REQUEST

Current Zoning: R-5 (single family residential)
Proposed Zoning: UR-2(CD) (urban residential, conditional)

Approximately 0.37 acres located at the southwest intersection of Parkwood Avenue and Harrill Street, east of Seigle Avenue.

SUMMARY OF PETITION

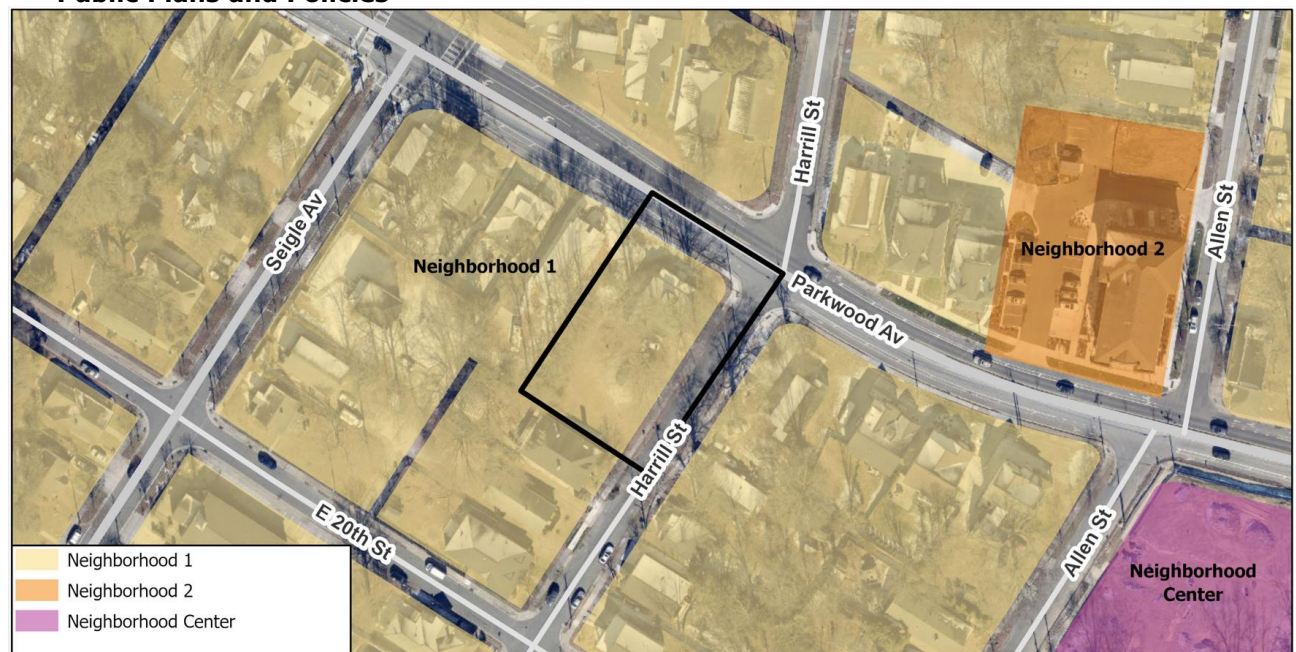
- ~~1. Curblin~~ The proposed zoning district has a setback measured from back of the existing or proposed future curblin.
 - ~~a. Parkwood Avenue: Future back of curb and gutter to be placed 27 feet from Parkwood Avenue road centerline.~~ Addressed
 - ~~b. Label and dimension the curb and gutter from the centerline for each road on the site plan.~~ Addressed
- ~~2. Label and dimension existing curblin measured from centerline of Parkwood Avenue. Show existing buffered bike lane (with dimensions) along Parkwood Avenue for CDOT to determine if existing conditions are to remain.~~ Addressed
- ~~3. Site plan and conditional note(s) revisions are needed to commit to construct bicycle facilities by locating the curb and gutter 27 feet from the Parkwood Avenue road centerline and installing an 8 foot buffered bike lane along Parkwood Avenue to meet the City Charlotte BIKE Policy.~~ Addressed

-
4. ~~A site plan note(s) specifying dedication and fee simple conveyance of all rights of way to the City before the site's first building certificate of occupancy is issued as needed. CDOT requests rights of way set at 2' behind back of sidewalk where feasible.~~ Addressed
 5. ~~Update conditional note to include a 2' sidewalk utility easement (SUE) instead of 1' to match site plan.~~ Addressed

6. Tree save must be comprised of existing trees. If replanted tree save must be done at 150%. Area shown on plan does not have existing trees. More tree save than what is shown would be required.

7. ~~Provide more clear architectural details on how Building 5 will interact with Harrill St. Need to define treating portions of the building as a front versus a side through things like a wrapped porch, door placement, or other design elements.~~ Addressed
-
